Public Hearing Date:	November 14, 2006
Land Use Action Date:	December 19, 2006
Board of Aldermen Action Date:	January 5, 2007
90-Day Expiration Date:	February 12, 2007

TO: Board of Aldermen

SUBJECT: Petition #349-06 of JOSEPH LONG for a SPECIAL PERMIT/SITE PLAN APPROVAL for a rear lot subdivision including a greater than 3 ft. grade change to create a new buildable lot on which a new single-family home, meeting all dimensional requirements, will be constructed at 11 GRAY BIRCH TERRACE, Ward 2, Newtonville, on land known as Sec 24, Blk 7, Lot 9, containing approx. 36,474 sf of land in a district zoned SINGLE RESIDENCE 2.

Existing two-family house and parking area

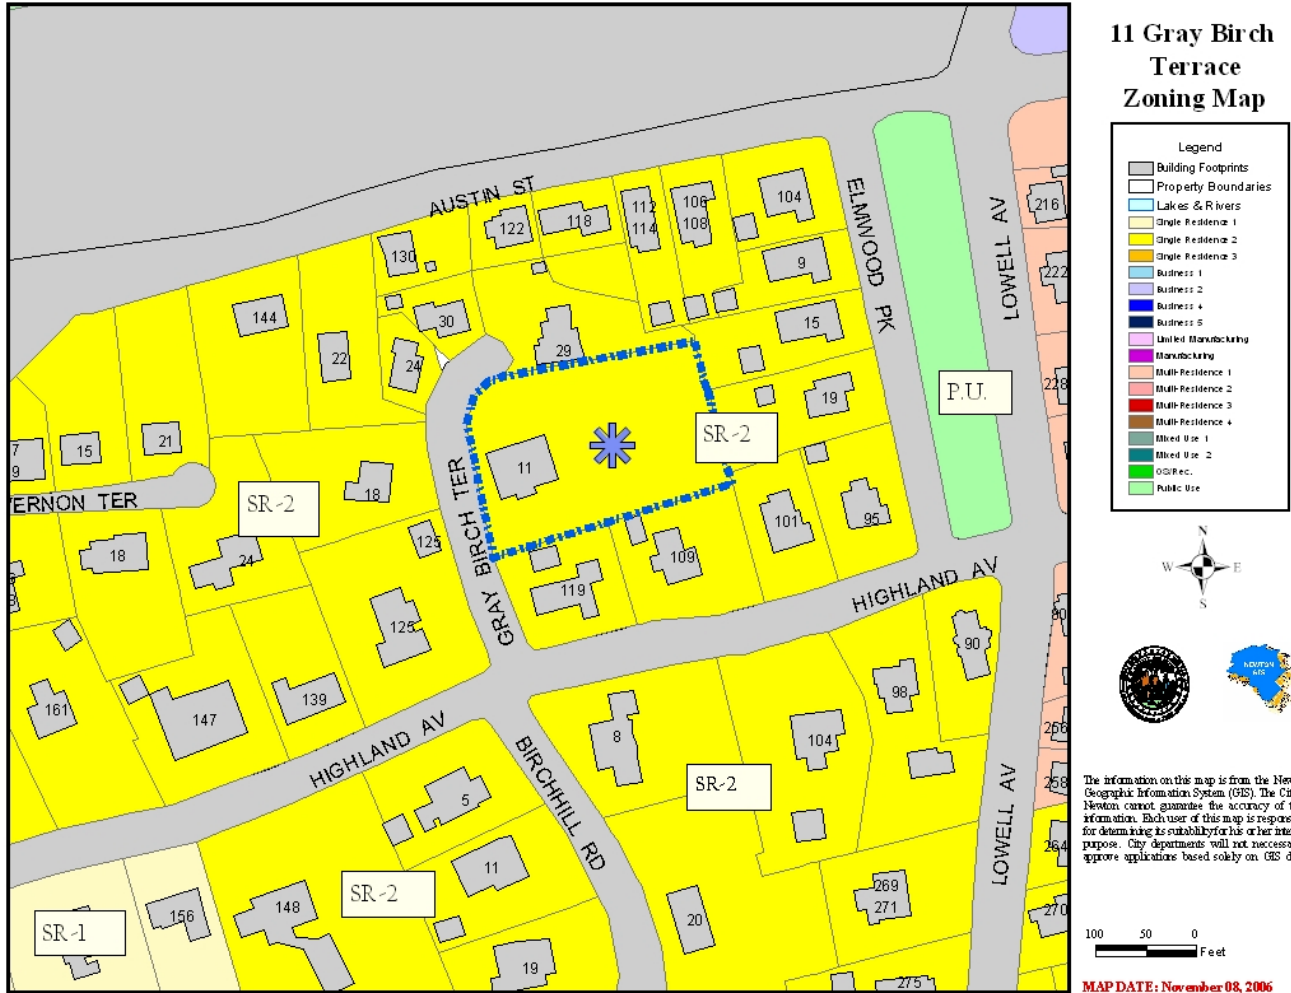
A bituminous driveway located east of the structure serves the existing non-conforming two-family dwelling with an accessory apartment. Though not dimensioned on submitted plans, existing parking stalls appear to be located in the front setback.

Proposed new rear lot

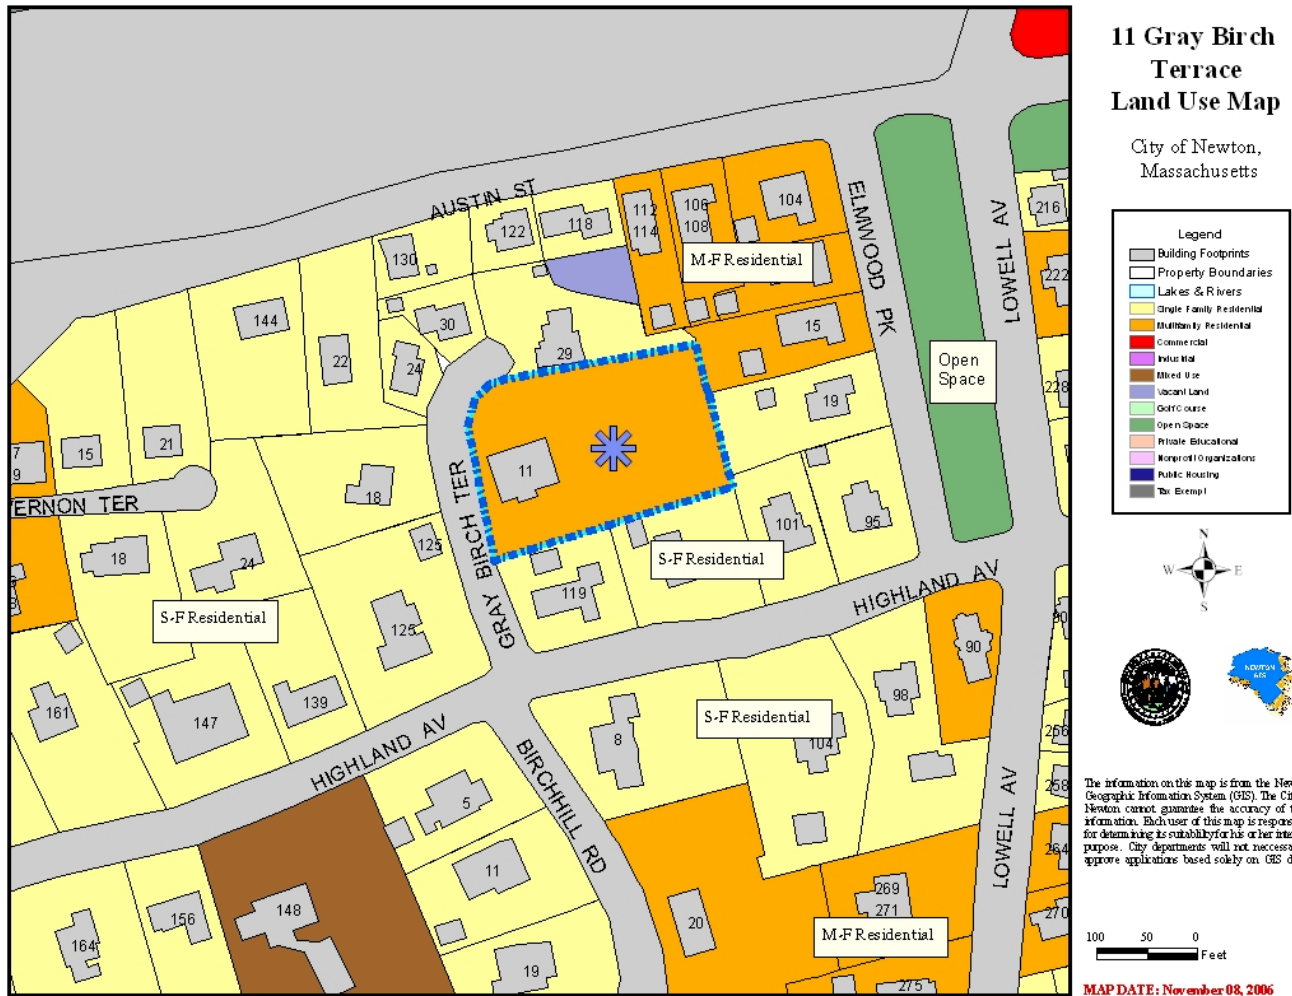
The rear portion of the existing lot is heavily wooded and slopes down to the north towards Lowell Avenue with an approximately 40 ft. grade differential from the southwest to the northeast corners. The site is the largest lot in the immediate area and is surrounded by single-family residences.
